Access Compliance Report

Public Rights-of-Way

Intersection ID: 15421	Main Street: ALPHA_ST	Cross Street: MARNEY_AV	Location:	N
ADA ID: DFA33F93D408	Ramp Type: PerpDiag	Initial Pass/Fail: Fail	Overall Compliance: No	Severity Score: 60

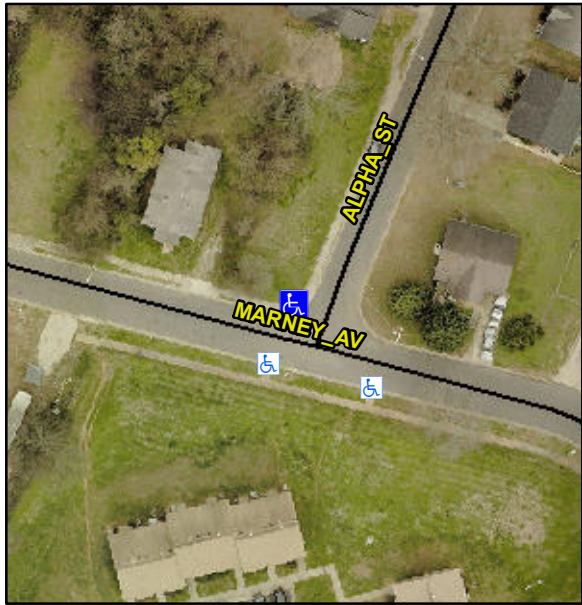
Codes/Mitigation Info/Possible Solution			Field Measurements/Component Compliance					
	Possible Solutions:		Compliance	Description	Data	Compliance	Description	Data
	Remove & Replace Curb Ramp With Two New Directional Ramps or Equivalent.		N/A	Ramp Length (in)	58.0	No	Ramp Slope (%)	9.1
			No	Ramp Width (in)	25.0	No	Ramp XSlope (%)	5.4
			N/A	Flare Type LT	N/A	N/A	Flare Type RT	N/A
			N/A	Flare Slope LT (%)	N/A	N/A	Flare Slope RT (%)	N/A
			N/A	Flare Traversable LT?	N/A	N/A	Flare Traversable RT?	N/A
			N/A	Landing Length (in)	N/A	N/A	DWS Provided?	N/A
			N/A	Landing Width (in)	N/A	N/A	DWS Contrast?	N/A
			N/A	Landing Slope (%)	N/A	N/A	DWS Length (in)	N/A
			N/A	Landing X Slope (%)	N/A	N/A	DWS Full Width?	N/A
Surveyor Notes:		N/A	N/A	Landing Curb? (Y/N)	N/A	N/A	DWS Offset (in)	N/A
PROW/ADA:		Not Found, R304.5.1, R304.2.2, R304.5.3	N/A	Shared Landing?	N/A			
			N/A	Gutter Ponding?	N/A	N/A	Gutter Slope (%)	N/A
